Monthly Specification Update

Intel® Storage Server System JBOD2000 Family

Intel Order Number H29869-001

November, 2013

Figure 1. Back-side View of JBOD2224S2DP

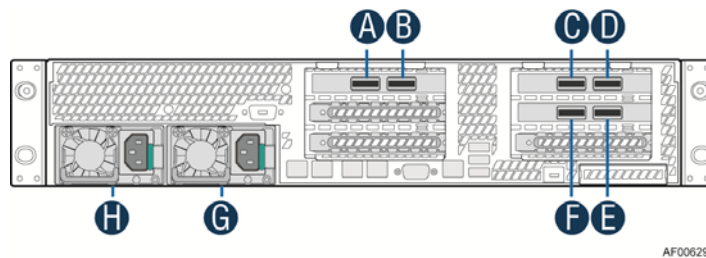
- Problem** Intel has determined that the storage server system JBOD2224S2DP may not be able to correctly read the system Enclosure ID, which is stored in an EEPROM on the power distribution board (PDB). The JBOD2224S2DP selects the SAS addresses of both expanders as the system Enclosure IDs. This will cause the JBOD2224S2DP to show incorrect system Enclosure IDs when it connects to other SAS devices.

- Implication** Customer data in the JBOD2224S2DP is safe in this scenario. Some dual-domain SAS related JBOD functions, such as MPIO and high-availability cluster, may not work properly due to the incorrect system Enclosure ID.

- Status** This issue will be fixed by replacing the existing PDB and updating the SAS expander FW. We estimate that the new PDB will be ready in Q1'14.

- Workaround** Use only the SAS SFF-8088 receptacle **A** and **B** of the JBOD2224S2DP instead of **C**, **D**, **E**, and **F** (see Figure 1). In this scenario the JBOD2224S2DP works in a single-domain SAS mode, which will not be impacted by this issue.
